## Application for Licence Amendment

**Licence Number** L7276/1996/12

**Premises** Murrin Murrin Nickel Cobalt Project

**Date of Report** 16 April 2025

Figure 1: TSF deposition point locations T4 and T5

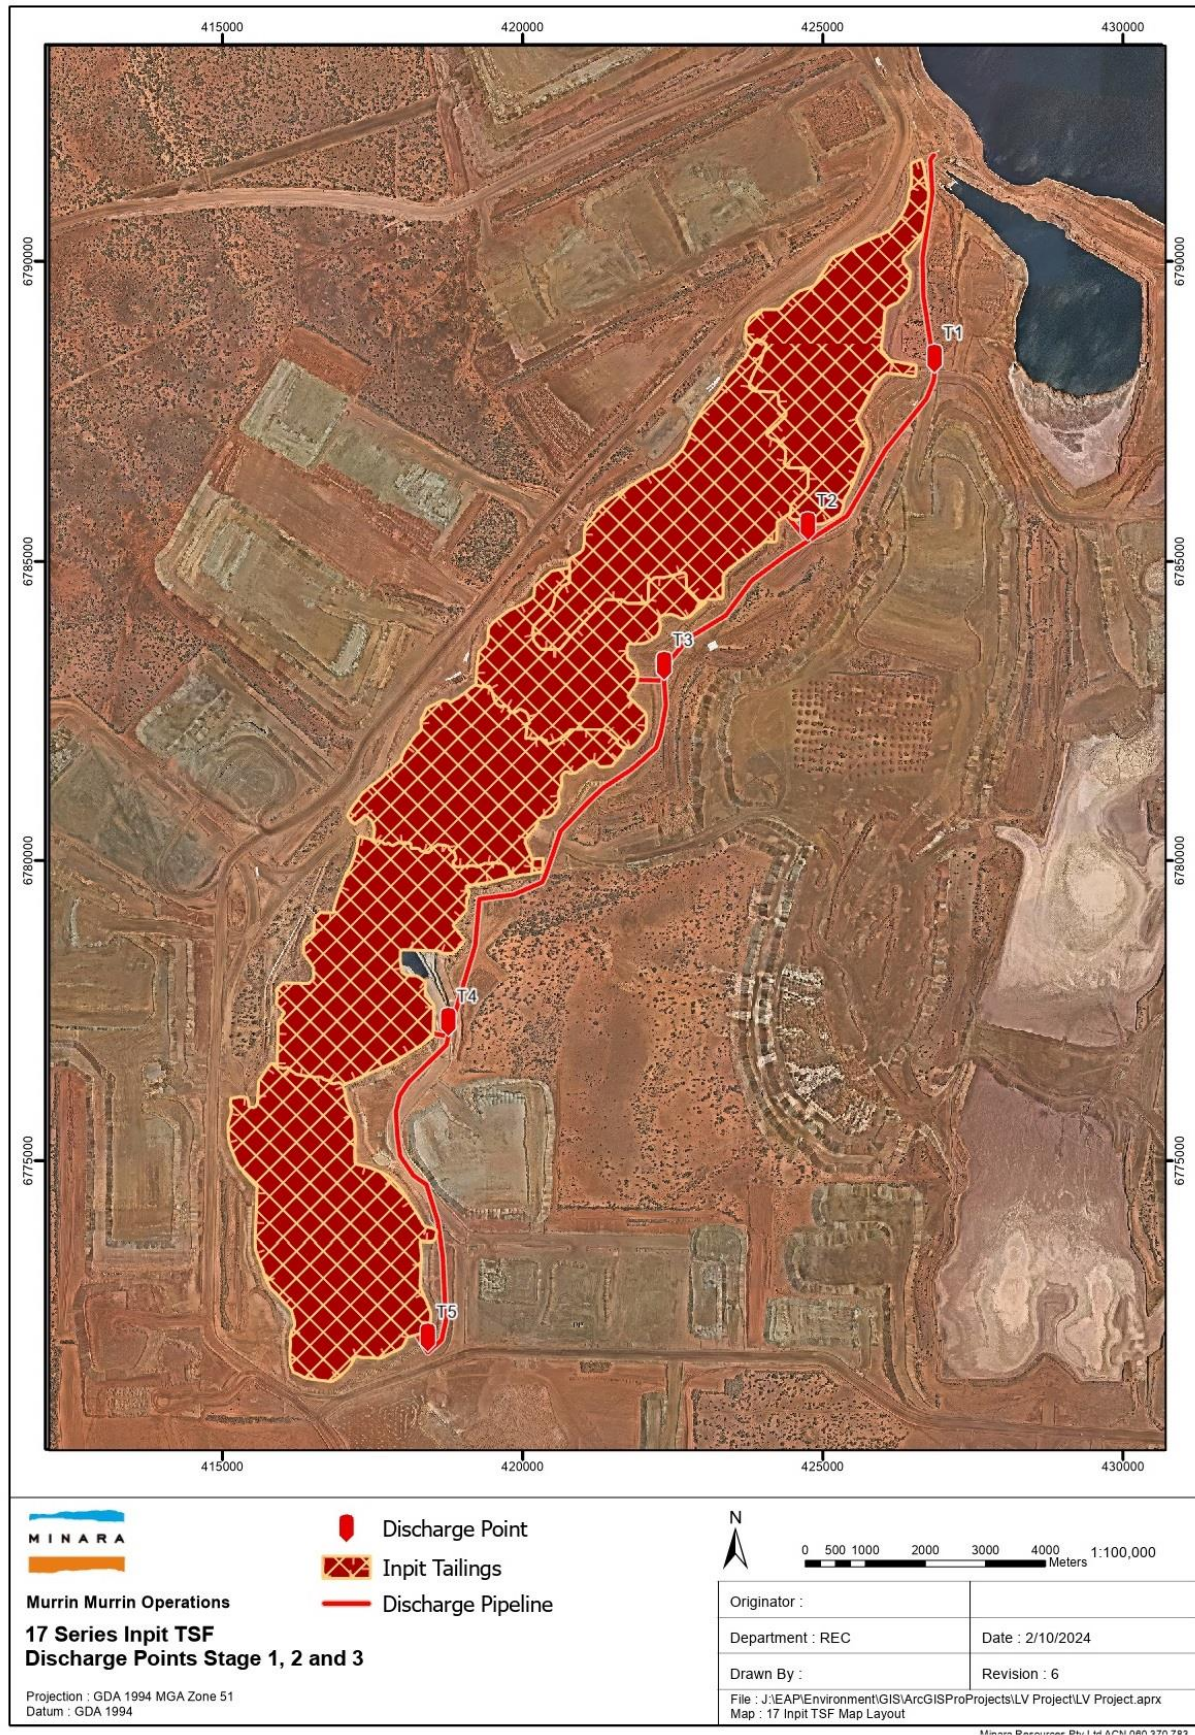
- Operation of the Stage 3 deposition points T4 and T5 at the 17 Series In-pit Tailings Storage Facility (TSF) on mining tenements M39/342, M39/343, M39/553, M39/424, M39/421 (refer to Figure 1).

**Figure 3 Standing water levels in the 17 series in-pit TSF groundwater monitoring bores**

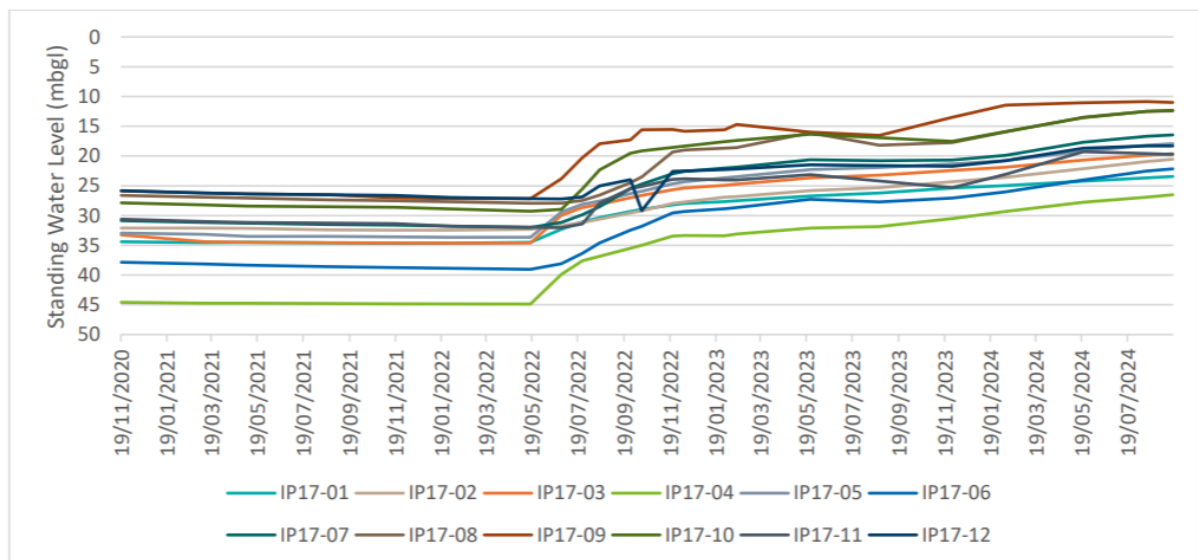
<p>monitoring bores):</p> <ul style="list-style-type: none"> <li>• Total Dissolved Solids (TDS): 414 mg/L to 1,500 mg/L (9 out of 12 bores). Brackish quality 1,630 – 2,320 mg/L (in 3 out of 12 bores).</li> <li>• PH – 7.89 to 8.66</li> <li>• Hydraulic conductivities typically lower on the eastern margin of the pit void due to geological characteristics.</li> </ul> <p><u>Current groundwater:</u></p> <ul style="list-style-type: none"> <li>• Groundwater relatively stable within most bores except 2, indicating saline water (TDS ranging 10,000 mg/L to 16,000mg/L).</li> <li>• PH range 6.60 to 8.60.</li> <li>• In June 2024 a slightly elevated nickel concentration was recorded at bore IP17-09 which is above the licence limit of 1 mg/L. During the subsequent monitoring (September 2024) nickel was reported with a concentration of 4.1mg/L.</li> </ul>	<p>45 mbgl.</p> <p>Current SWL: 11 - 27 mbgl</p> <p>Results measured in groundwater monitoring bores around TSF: IP17-01 to IP17-12 as displayed in Figure 3.</p>

Potentially contaminated groundwater resulting from seepage is highly unlikely to reach roots of vegetation as shown by historical groundwater data at the 17 Inpit TSF and historical groundwater monitoring at all other eight in-pit TSFs. SWL have also remained below the trigger value of 6 m as specified in L7276. During and after deposition it is expected that	The Delegated Officer agrees based on SWL that the relevant environmental value and therefore applicable ANZECC guideline criteria is livestock drinking water post-mining and has determined to adopt
